Access Compliance Report

Public Rights-of-Way

(Curb Ramps)

Intersection ID: 26068	Main Street: BAYBROOK_LN	Cross Street: PINEVILLE-MATTHEWS_RD	Location: NW
ADA ID: 80BE1973CE5F	Ramp Type: PerpDiag	Initial Pass/Fail: Fail	Overall Compliance: No
Severity Score: 13.75			
Codes/Mitigation Info/Possible Solution		Field Measurements/Component Compliance

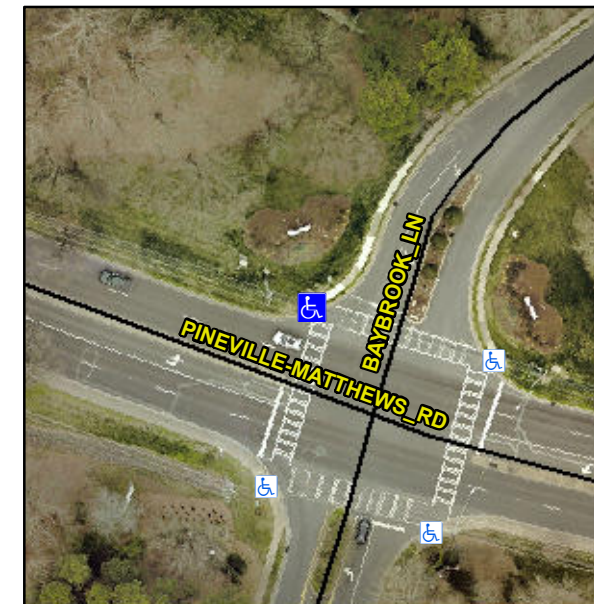
Remove & Replace Curb Ramp With Two New Directional Ramps or Equivalent. Restripe Crosswalk.

Not Found, R304.2.2, R304.5.3

Compliance	Description	Data	Compliance	Description	Data
N/A	Ramp Length (in)	72.0	No	Ramp Slope (%)	10.7
Yes	Ramp Width (in)	48.0	No	Ramp XSlope (%)	2.6
N/A	Flare Type LT	N/A	N/A	Flare Type RT	N/A
N/A	Flare Slope LT (%)	N/A	N/A	Flare Slope RT (%)	N/A
N/A	Flare Traversable LT?	N/A	N/A	Flare Traversable RT?	N/A
N/A	Landing Length (in)	N/A	N/A	DWS Provided?	N/A
N/A	Landing Width (in)	N/A	N/A	DWS Contrast?	N/A
N/A	Landing Slope (%)	N/A	N/A	DWS Length (in)	N/A
N/A	Landing X Slope (%)	N/A	N/A	DWS Full Width?	N/A
N/A	Landing Curb? (Y/N)	N/A	N/A	DWS Offset (in)	N/A
N/A	Shared Landing?	N/A			
N/A	Gutter Ponding?	N/A	N/A	Gutter Slope (%)	N/A
N/A	Gutter Lip Ht (in)	N/A	N/A	Gutter X Slope (%)	N/A
N/A	Painted X Walk1?	Yes	N/A	Painted X Walk2?	Yes
	X Walk 1 Direction	To SW		X Walk 2 Direction	To SE
N/A	X Walk 1 Width (in)	131.0	N/A	X Walk 2 Width (in)	124.0
	X Walk 1 Slope (%)	3.3		X Walk 2 Slope (%)	4.8
	X Walk 1 X Slope (%)	4.7		X Walk 2 X Slope (%)	2.3

N/A	Ramp inside XWalk1?	No	N/A	Ramp inside XWalk2?	Yes
	Road Slope (%)	1.9	N/A	Clear Space?	N/A
	Road X Slope (%)	5.5	N/A	Clear Space to XWalk (in)	N/A
N/A	Any Obstructions?	N/A	N/A	Storm Grate/Utility Hazard?	N/A
	Obstruction Type			Storm Grate/Utility Type	
		N/A			N/A
		Yes		Surface Condition? (G/P)	Good
